Merged Document Report

Application No.: PL9299

Document Filename
Laguna Oaks Estates_ Block 1_ Lots 1-10.pdf

LAGUNA OAKS ESTATES, BLOCK 1, LOTS 1-10

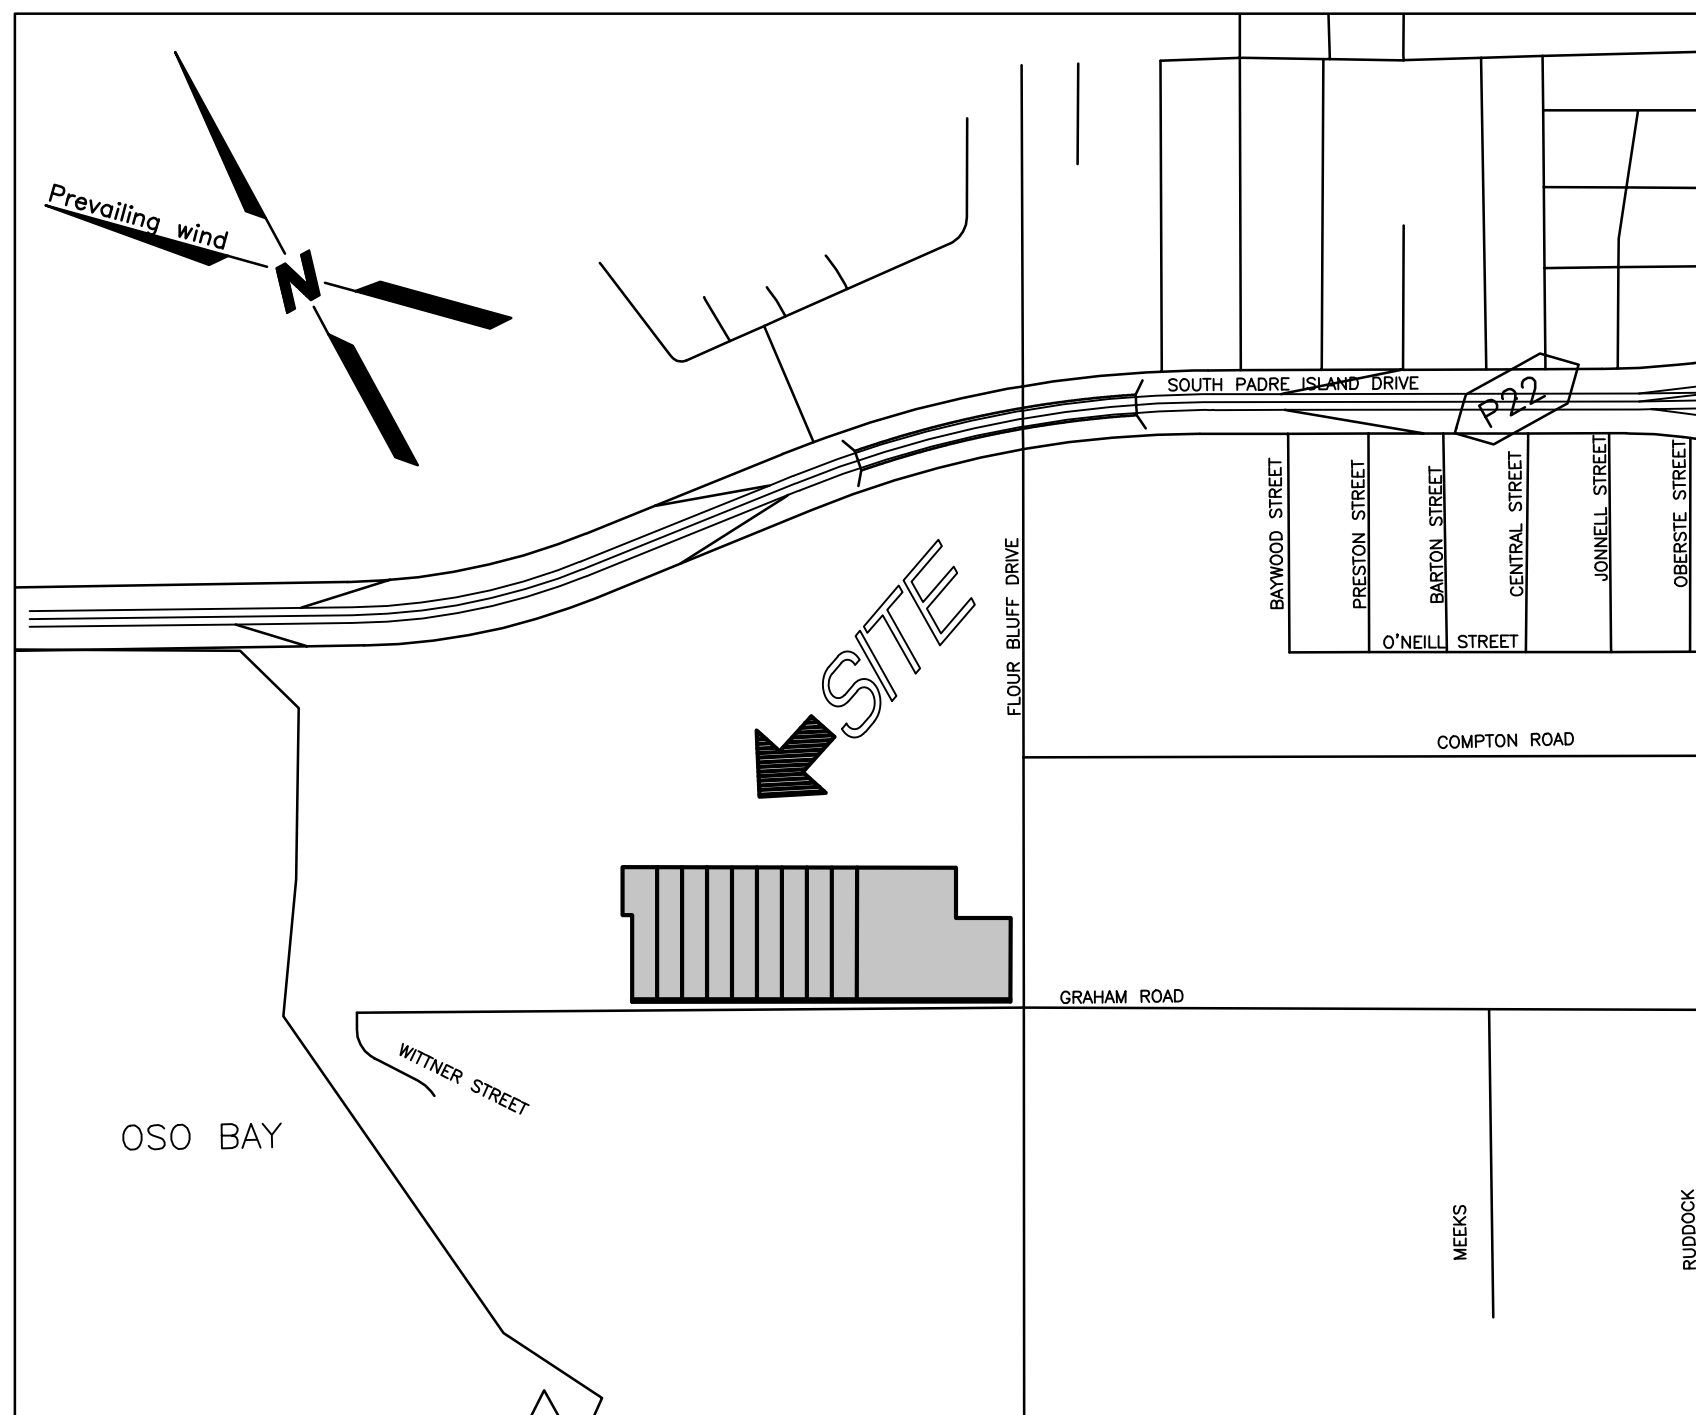
Comment ID	Page Reference	Annotation Type	Author : Department	Status	Review Comments	Applicant Response Comments
5	P001	Note	Bria Whitmire : DS	Closed	Improvements Required for Recordation, per UDC 8.1.4. A. Streets: no Sidewalks: no B. Water: no (EACH lot must have individual access and provide connectivity to neighboring lot) Fire hydrants: not for platting, possibly for site development (nearest hydrant must be 300 feet for commercial, 600 for residential) C. Wastewater: no, with approval of septic (EACH lot must have individual access and provide

Comment ID	Page Reference	Annotation Type	Author : Department	Status	Review Comments	Applicant Response Comments
					<p>connectivity to neighboring lot)</p> <p>D. Stormwater: no, however site development must mitigate any increase of stormwater runoff-post development flow cannot exceed pre development flow</p> <p>E. Public open space: no (UDC 8.3)</p> <p>F. Permanent monument markers: no</p> <p>Please note, improvements required should be constructed to city standards, found in Article 8 and the IDM.</p>	
5	P001	Note	Bria Whitmire : DS	Open	<p>Improvements Required for Recordation, per UDC 8.1.4.</p> <p>A. Streets: no</p> <p>Sidewalks: no</p> <p>B. Water: no (EACH lot must have individual access and provide connectivity to neighboring lot)</p> <p>Fire hydrants: not for platting, possibly for site development (nearest hydrant must be 300 feet for commercial, 600 for residential)</p> <p>C. Wastewater: yes, unless waiver approved for septic within 1,000 of public main (EACH lot must have individual access and provide connectivity to neighboring lot)</p> <p>D. Stormwater: no, however site development must mitigate any increase of stormwater runoff-post development flow cannot exceed pre development flow</p> <p>E. Public open space: no (UDC 8.3)</p> <p>F. Permanent monument markers: no</p> <p>Please note, improvements required should be constructed to city standards, found in Article 8 and the IDM.</p>

6	P001	Note	Bria Whitmire : DS	Closed	<p>Driveway Permits (sizing and spacing) and ROW Permits (any work in ROW including utility tie-ins) to be obtained from Public Works at Link</p>	
6	P001	Note	Bria Whitmire : DS	Closed	<p>Driveway Permits (sizing and spacing) and ROW Permits (any work in ROW including utility tie-ins) to be obtained from Public Works at Link</p>	
7	P001	Note	Mark Zans : LD	Closed	<p>Change Michael York to Cynithia Salazar-Garza</p> <p>Change chairman to Chairperson.</p>	
7	P001	Note	Mark Zans : LD	Closed	<p>Change Michael York to Cynithia Salazar-Garza</p> <p>Change chairman to Chairperson.</p>	
8	P001	Note	Mark Zans : LD	Closed	<p>Change Michael Dice title to Interim Asst. City Manager</p>

12	P001	Note	Mark Zans : LD	Closed	Will there be a HOA for this plat? If yes, please provide HOA documents at time of recording.	
12	P001	Note	Mark Zans : LD	Closed	Will there be a HOA for this plat? If yes, please provide HOA documents at time of recording.	
13	P001	Note	Mark Zans : LD	Closed	Stormwater comments: Informational only Please review IDM Ch. 3.05: No Adverse Impacts. For new developments and other improvements that will increase the impervious cover, decrease the time of concentration (Tc), or increase peak flows from drainage areas, mitigation of adverse storm water impacts shall be required. Mitigation methods shall be designed to release the

Comment ID	Page Reference	Annotation Type	Author : Department	Status	Review Comments	Applicant Response Comments
					<p>post-development storm water runoff from a site at a controlled rate, which does not exceed the predeveloped peak runoff rate. Habitable structures must be mitigated to the 100 yr-storm event, per UDC 8.2.8.</p> <p>If local private on-site storm water detention facilities are provided, they shall be designed using the appropriate methodology for their acreage and require a licensed professional engineer to inspect and certify that the facility is functioning as originally designed.</p>	
13	P001	Note	Mark Zans : LD	Closed	<p>Stormwater comments: Informational only Please review IDM Ch. 3.05: No Adverse Impacts. For new developments and other improvements that will increase the impervious cover, decrease the time of concentration (Tc), or increase peak flows from drainage areas, mitigation of adverse storm water impacts shall be required. Mitigation methods shall be designed to release the post-development storm water runoff from a site at a controlled rate, which does not exceed the predeveloped peak runoff rate. Habitable structures must be mitigated to the 100 yr-storm event, per UDC 8.2.8.</p> <p>If local private on-site storm water detention facilities are provided, they shall be designed using the appropriate methodology for their acreage and require a licensed professional engineer to inspect and certify that the facility is functioning as originally designed.</p>

14	P001	Note	Mark Zans : LD	Closed	<p>Sewer comment: Property will need wastewater wavier for use of septic tanks if approved for septic.</p>	
14	P001	Note	Mark Zans : LD	Open	<p>Sewer comment: Property will need wastewater wavier for use of septic tanks if approved for septic.</p>	
15	P001	Note	Mark Zans : LD	Closed	<p>Fire comments#1: Informational only:</p> <p>Please see Fire's Comments PL9299 Laguna Oaks Estates Lots 1-10. Note: All code reference is based on currently adopted International Fire Code (IFC) 2021 and Corpus Christi Water Distribution Standards. "Commercial Development shall have a fire flow of 1,500 GPM with 20 psi residual. Fire hydrant every 300 feet and operational."</p> <p>507.5.1 (amendment) Where Required: All premises, other than one-family detached dwellings, where buildings or portions of buildings are located more than 150 feet from a fire hydrant</p>

16	P001	Note	Mark Zans : LD	Closed	<p>Fire comments #2: Informational only.</p> <p>D103.1 Access Road width with a hydrant. Where a fire hydrant is located on a fire apparatus access road, the minimum road width shall be 26 feet, exclusive of shoulders.</p>

17	P001	Note	Mark Zans : LD	Closed	<p>Parks comment: Fees applied on 9 of the 10 lots to be developed. As 9 of these lots are to be used for a newly proposed residential dwelling unit, fees are to be applied. 9 lots x 462.50 = \$4,162.50</p>	
18	P001	Note	Mark Zans : LD	Closed	<p>Traffic comments #1: PLAT – ROADWAY MASTER PLAN <ul style="list-style-type: none"> •□The proposed plat does not impact or alter the existing Transportation Master Plan. o□The plat did provide adequate ROW dedication as required per the RMP. TRAFFIC – PEAK HOUR TRAFFIC / TIA: <ul style="list-style-type: none"> •□Peak Hour Traffic (PHT) form shows an excess of 500 trips for both the AM peak trips times & the PM peak trip times. A Traffic Impact Analysis (TIA) will be required to be submitted to Public Works Traffic for review and approval. (please contact PW – Traffic / ROW for further guidance regarding TIA) o□As per Corpus Christi Unified Development Code Section 3.29.5. Study Area Requirements <ul style="list-style-type: none"> □□Level 1Traffic Impact Analysis- Peak hour weekday PM Trips 501-1,500 □□Study boundary – all signalized intersections, frontage roads and all unsigned collector or higher intersections within .50 miles of the site </p>

19	P001	Note	Mark Zans : LD	Closed	<p>Traffic comments #2: PLAT – COMMENT: (CITY ACCESS MANAGEMENT / ROW) •□A ROW Construction Permit, issued by PW-Traffic Department (Right-of-Way Division), is required for any proposed driveway (construction entrance, temporary or permanent), work obstructing, closing, or occupying public right-of-way (Reference Chapter 49-2). o□The ROW Construction permit must be submitted and approved prior to any form of construction within City ROW. o□The developer / applicant can reach out to rowmanagement@corpuschristitx.gov for further assistance regarding the ROW Construction Permit they will be required to submit prior to any temporary and / or permanent driveway off the immediate roadways. o□Any contractor working within City ROW without an approved ROW Construction Permit can be held in non-compliance and can be subject to a fee of \$1,500 per day of unpermitted work, as per City of Corpus Christi Municipal Code 49-112 (9). •□The PW-Traffic Department (Right-of-Way Division) is responsible for reviewing and permitting new construction and repairs/modifications to driveways, sidewalks, curb, and gutter or any work within utility easements. o□All work shall be performed in accordance with the city's construction standards. A permit shall not</p>
